Subject: FW: Georgian Woodlands Draft Plan Extension Deputation Materials (0196-5928)

MEMO

DATE November 1, 2024
RE Georgian Woodlands Sanitary Servicing**PROJECT NO.** 196-5928**TO** Brian Worsley, P. Eng., Manager of Development Engineering
FROM George Cooper, P. Eng. & Jon Proctor, P. Eng.
CC Alexander Fleming

This memorandum has been prepared in support of the proposed sanitary servicing strategy for the Georgian Woodlands Phase IV Stage 3 Residential Development. The second detailed design submission, prepared by C.F. Crozier and Associates (Crozier) dated January 26, 2024 proposed a low pressure sanitary forcemain with individual grinder pumps located within each of the 37 lots. Based on discussions with Town staff and the comments issued by the Town, dated June 3, 2024, we understand that the Town's preference for sanitary servicing would be via gravity sewer and sewage pumping station (SPS). Based on discussions with Town staff, our office is aware of the challenges the Town has encountered with low-pressure systems (LPS) in existing developments and the Town's concerns about expanding the use of these systems for future residential developments.

Drawing C103.A – Fleming Gate Plan & Profile (STA 0+000 –
0+166)

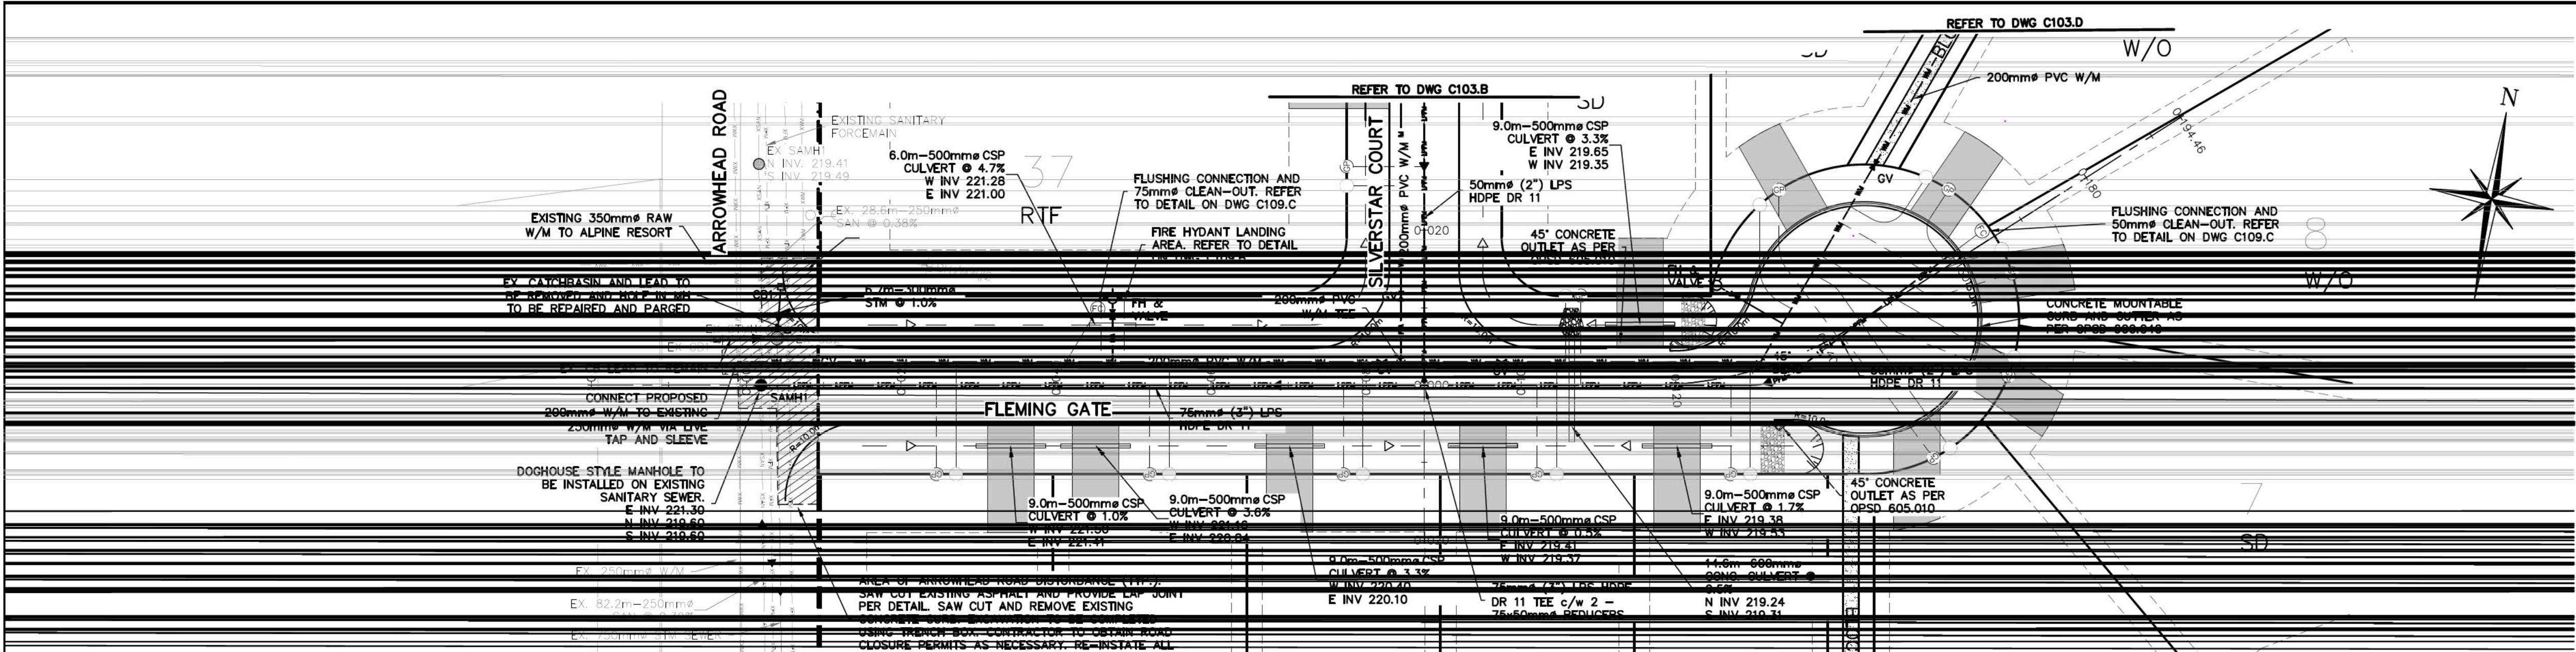
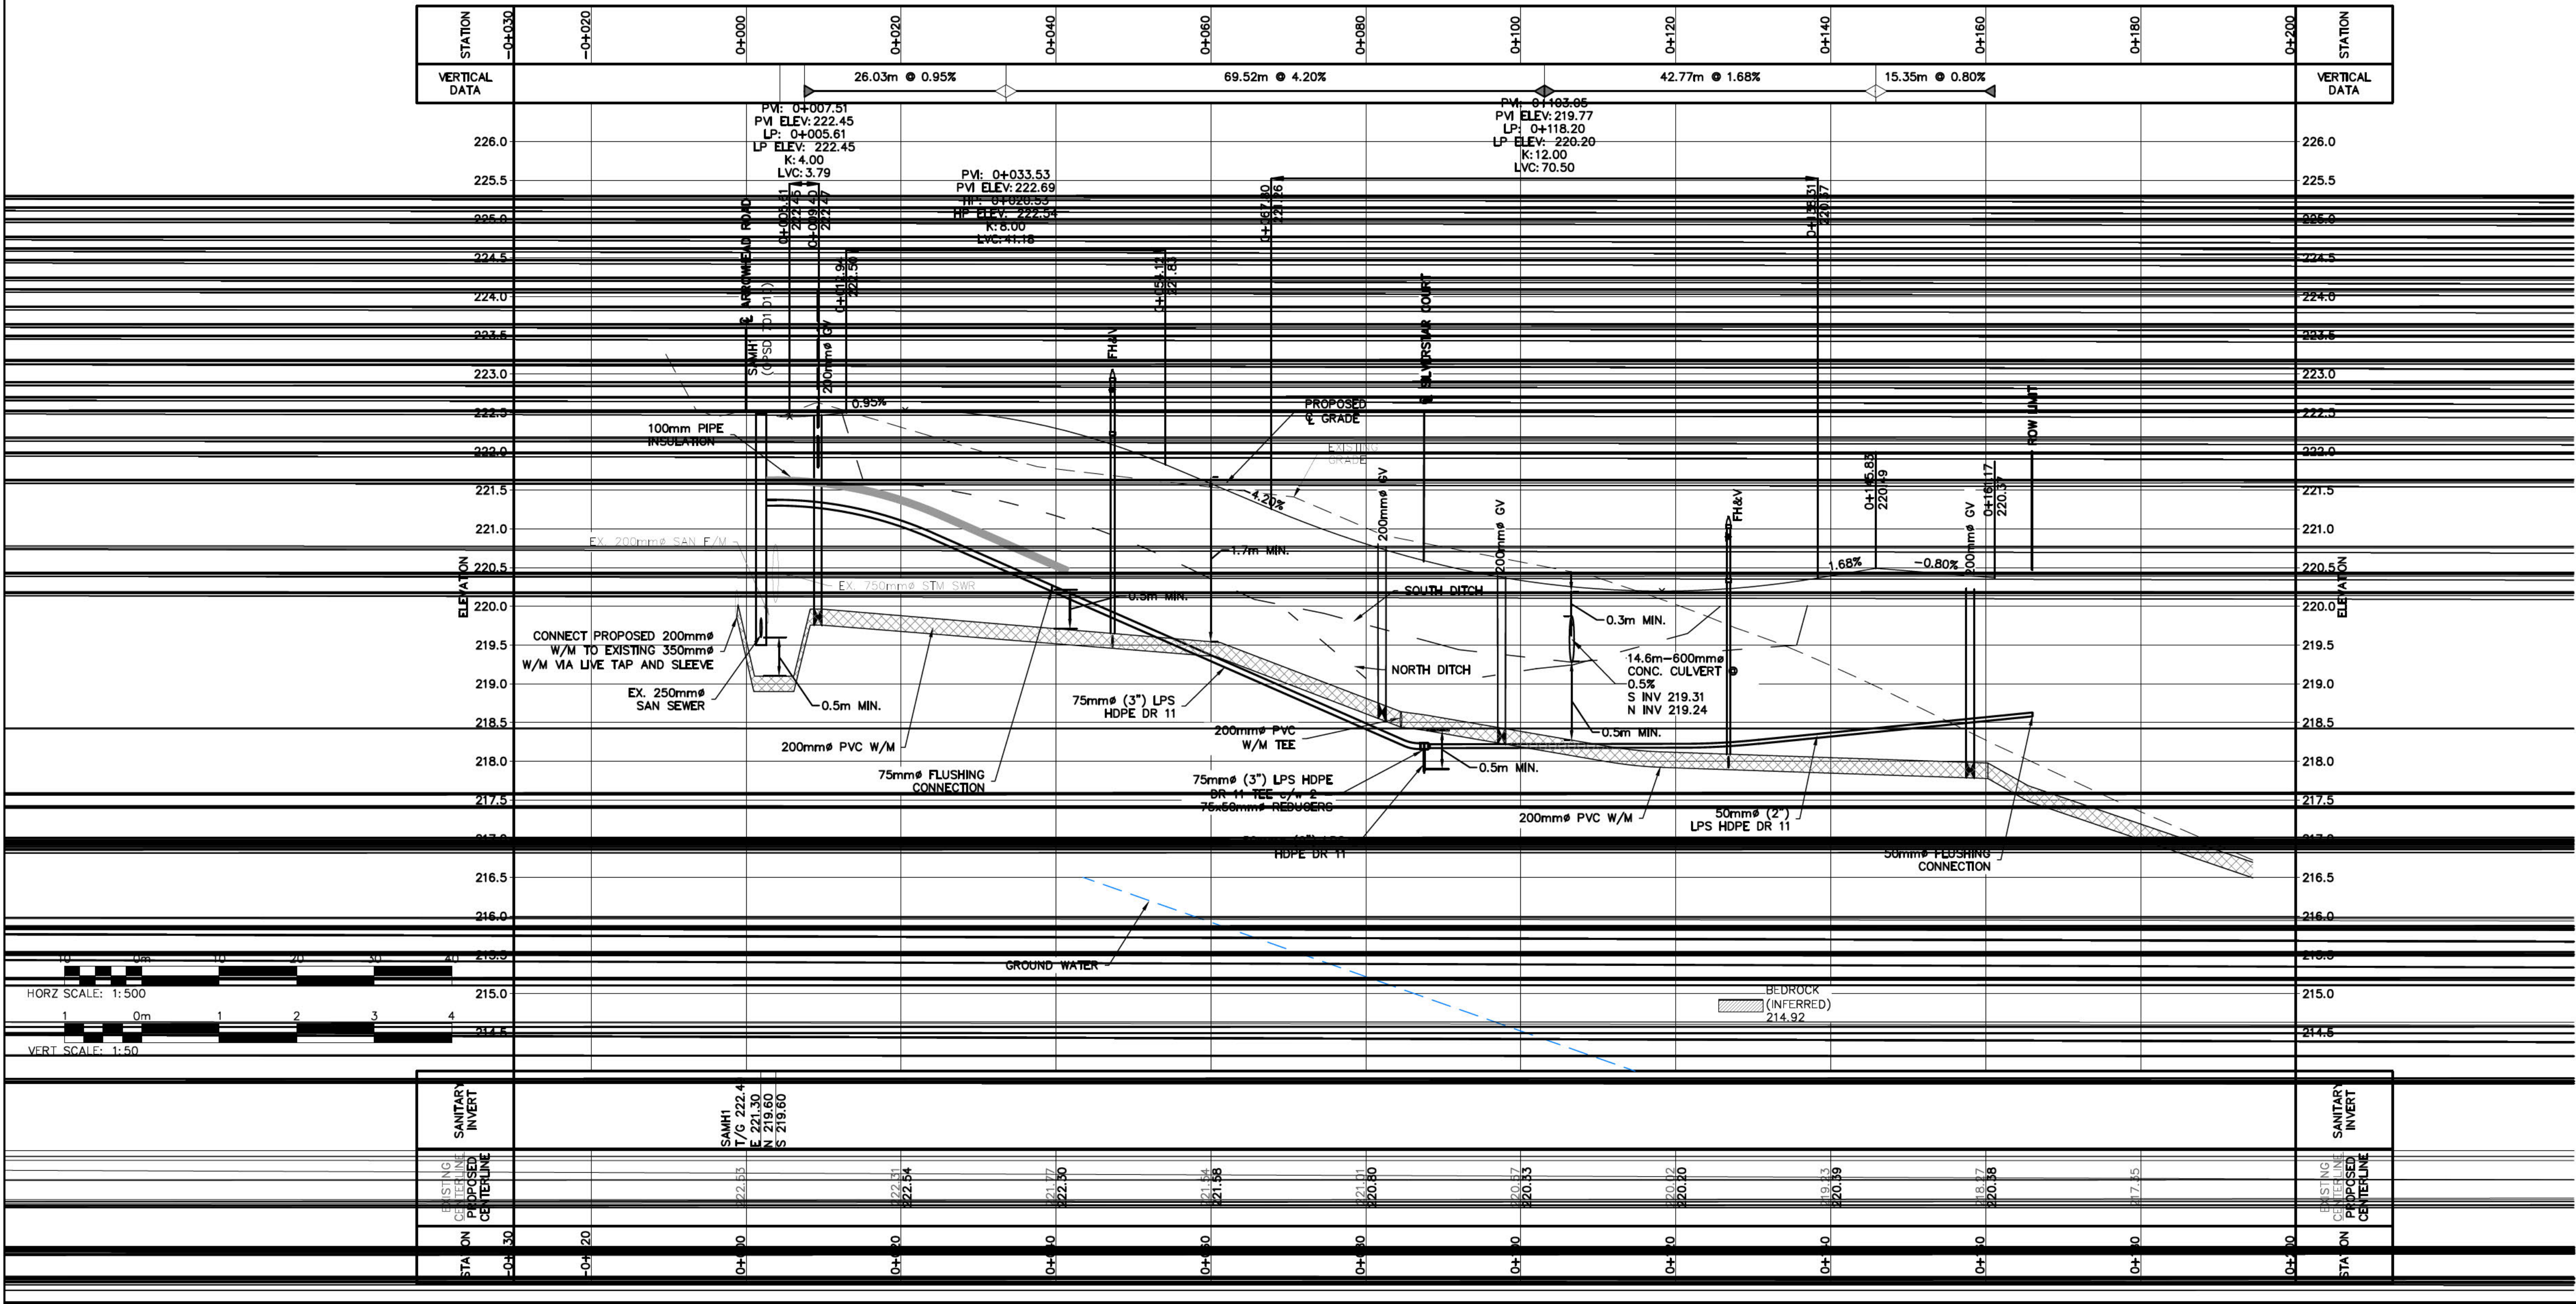
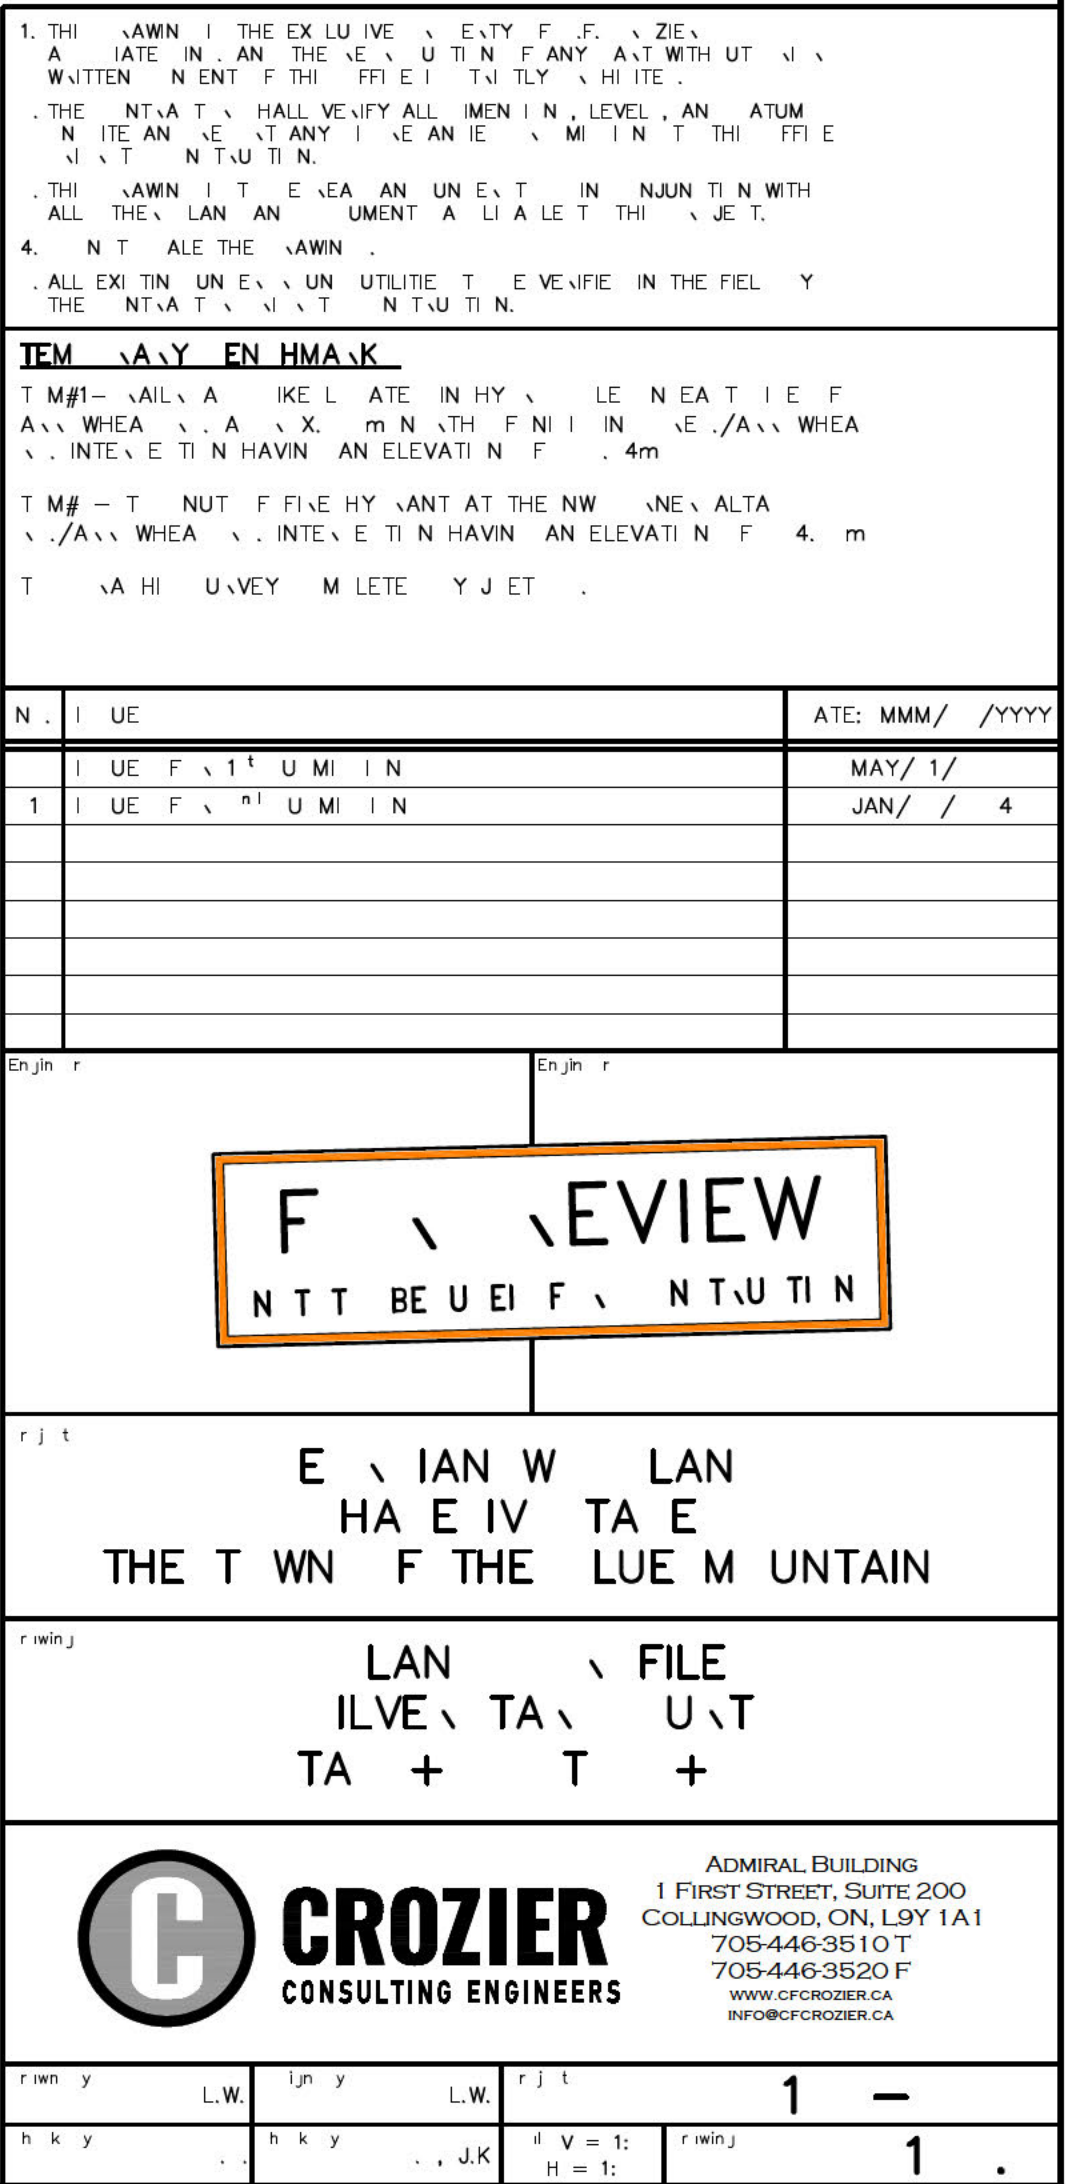
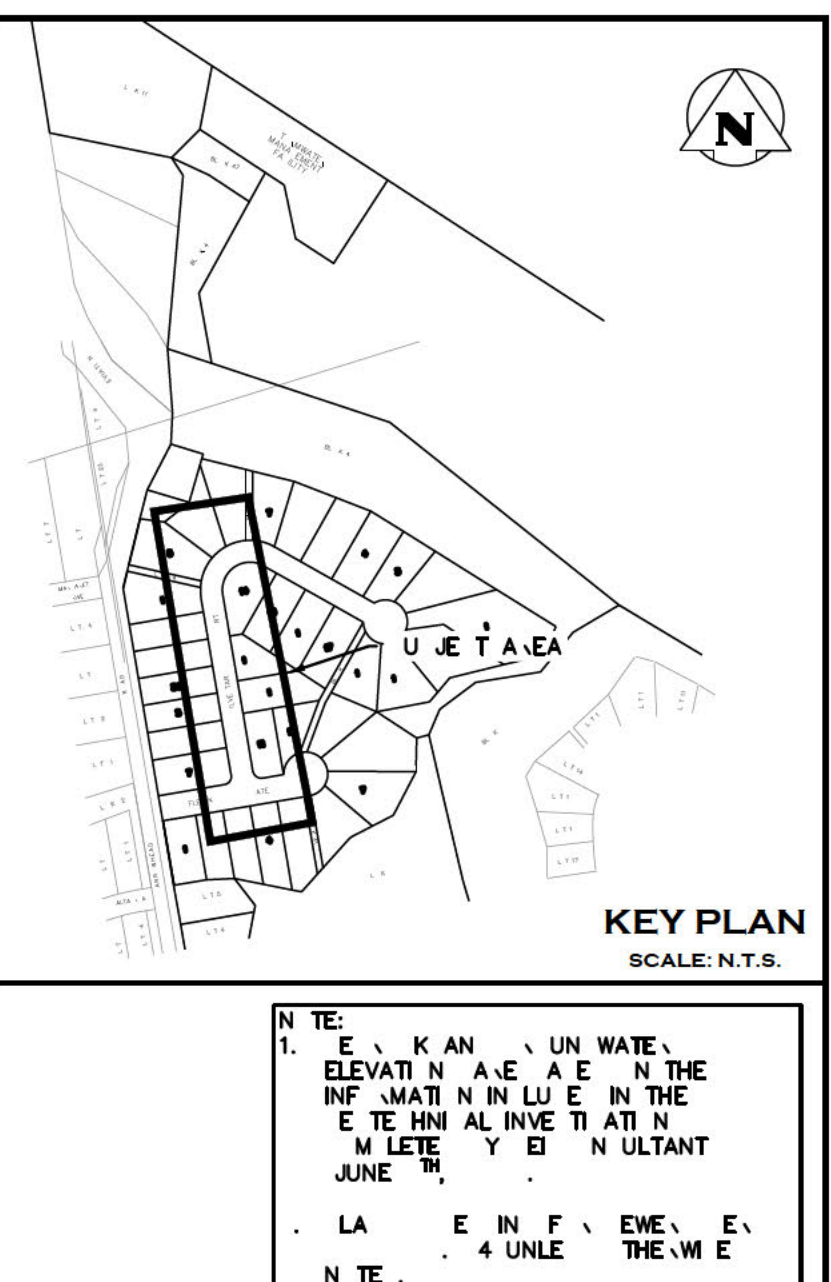
Since a detailed design submission had been issued to the Town prior to the 2023 Engineering Standards came into effect, it was understood that Stage 3 would still be subject to the 2009 Engineering Standards which do not exclude the use of low pressure sanitary systems. Our office prepared a 2nd Detailed Design Submission, which continued to propose a low pressure system. A deviation form was also prepared, highlighting the rationale for proposing the low pressure system. The rationale focused on the higher capital / life cycle costs of a sewage pumping station and potential maintenance issues as a result of hydrogen sulfide caused by infrequent pumping due to the low flows / seasonal nature of the residents. It was also noted that incorporating a sewage pumping station would impact the lot fabric of the Draft Plan that was approved through the Ontario Land Tribunal (OLT) process and may result in the loss of a unit. The 2nd Submission was issued to the Town on January 26, 2024, refer to the Plan and Profile Drawings enclosed within this memo.
